APPLICATION NO.	FILING DATE	FIRST NAMED INVENTOR	ATTORNEY DOCKET NO.	CONFIRMATION NO.
10/643,543	08/19/2003	Georg Wall	HBC 251-KFM 17657-US	4260

Office Action Summary	Application No. 10/643,543	Applicant(s) WALL, GEORG	
	Examiner Chi Q. Nguyen	Art Unit 3635

DETAILED ACTION

FIG. 2.

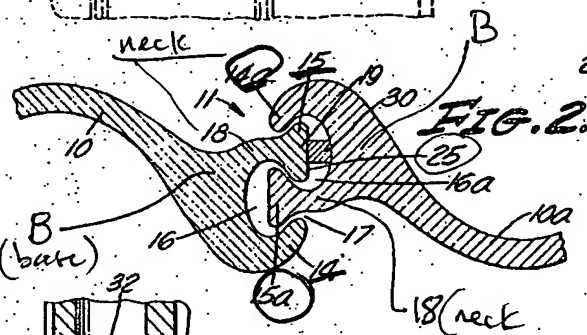
In regard claim 1, Hunsucker teaches interlocking sheet piles and method of installation comprising two interlocking strip shaped joining elements 10, 10a. Each of the joining elements comprising a neck strip 18 projecting away from a base B (see attachment of figure 2), an adjoining button strip 14 and the second joining element 15

and the being affixable with a base B and comprises two hook strips 25 projecting away from the base B and encompass the button strip 14 of the first joining element inserted into hollow space 16a so that it is held in the hollow space 16a, characterized in that the base B of the first joining element comprises on its two longitudinal sides, the two hook strips serve as holding portions projecting away from the base which embrace outer sides of the hook strips of the second joining element. Since Hunsucker teaches the similar structures as the applicant's claimed invention, it's inherently capable of performing the same function such as preventing a widening of the hook strips in the case of tensile forces between the two individual elements.
